REMARKS

Applicant's Attorney has requested several changes to the drawings to correct a self-evident error and to improve clarity. In particular, Applicant's Attorney has requested that:

NS-5127

Fig. 15

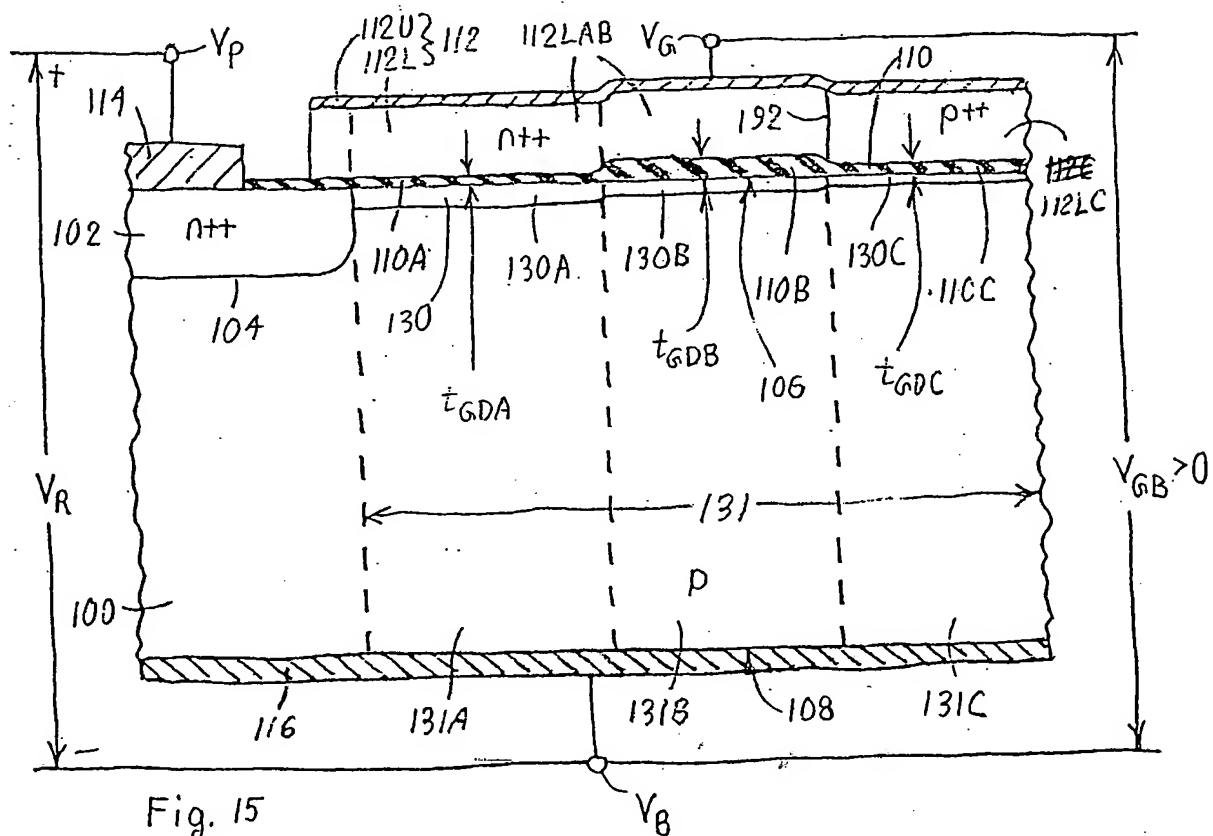
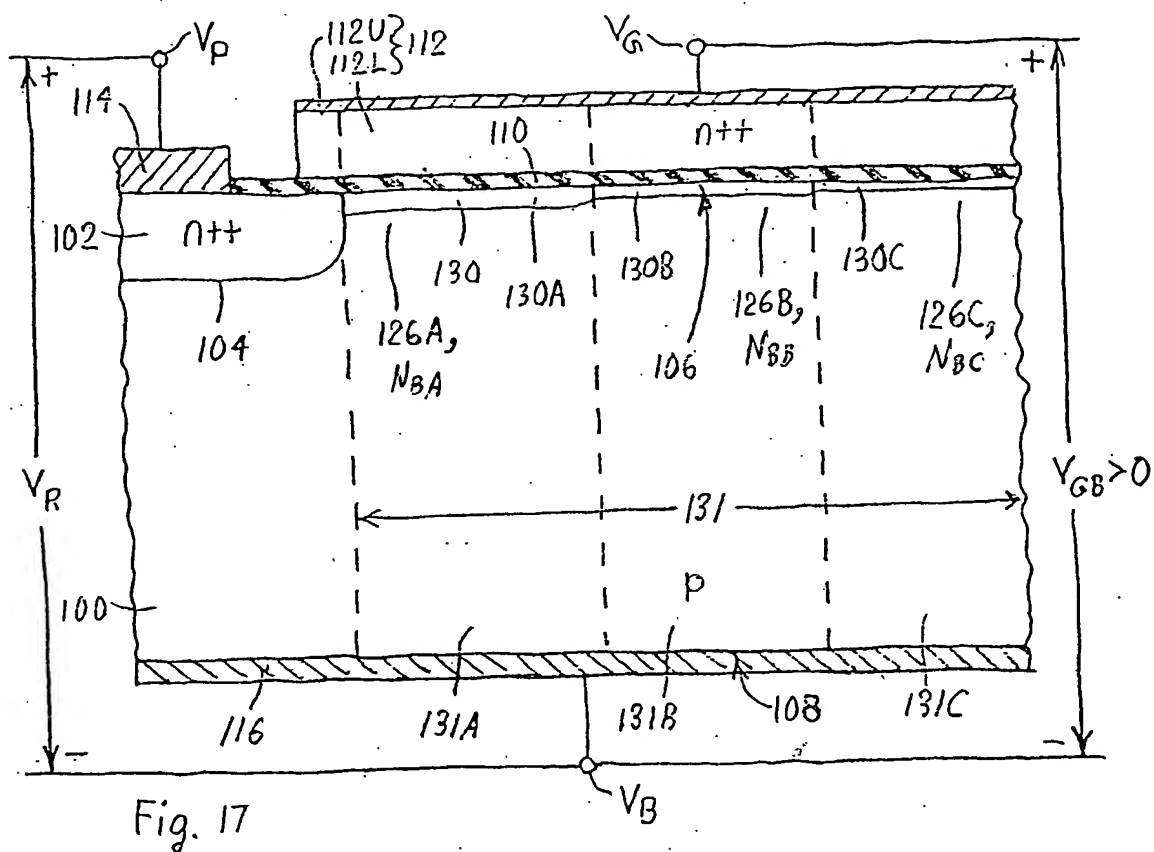
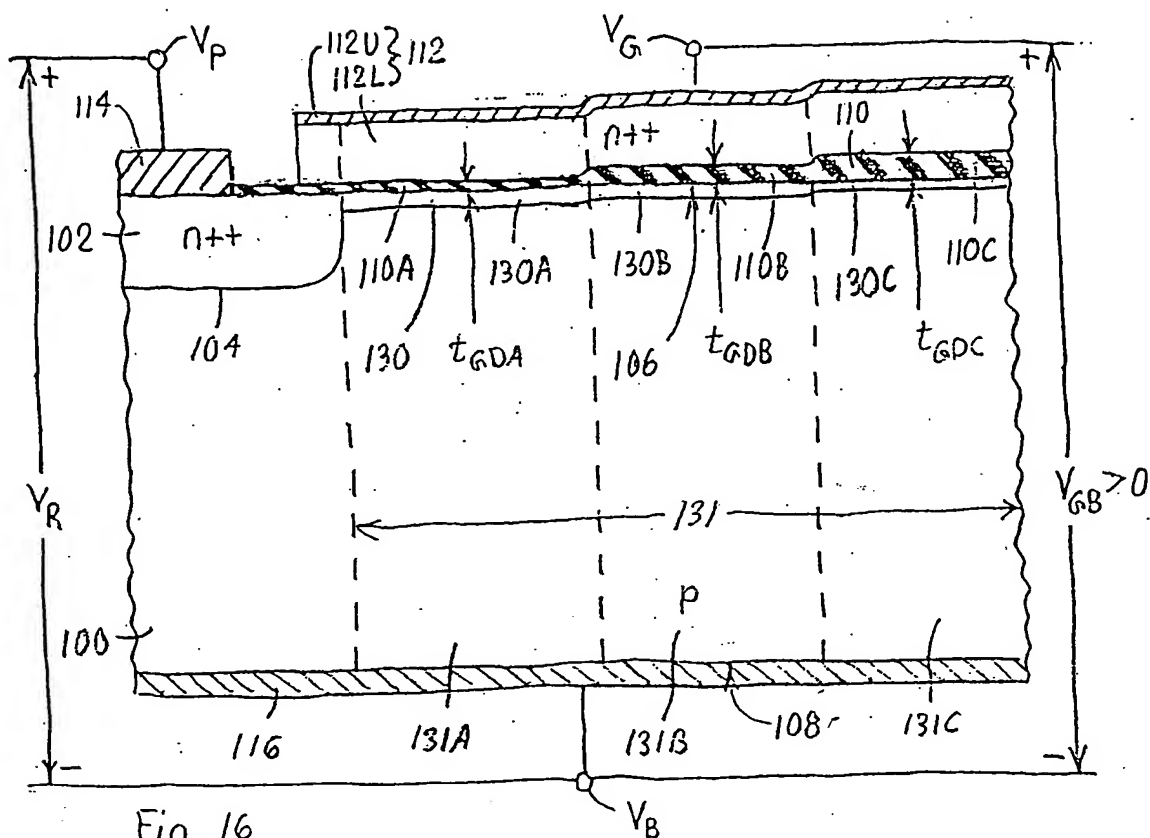
a. Reference symbol "112C" for the p++ lower right-hand gate electrode portion in Fig. 15 be changed to "112LC" in conformity with the disclosure in paragraph 198 of the specification that lower gate electrode layer 112L in Fig. 15 consists of very heavily doped n-type polycrystalline silicon ("polysilicon") gate electrode portion 112LAB and very heavily doped p-type polysilicon gate electrode portion "112LC"; and
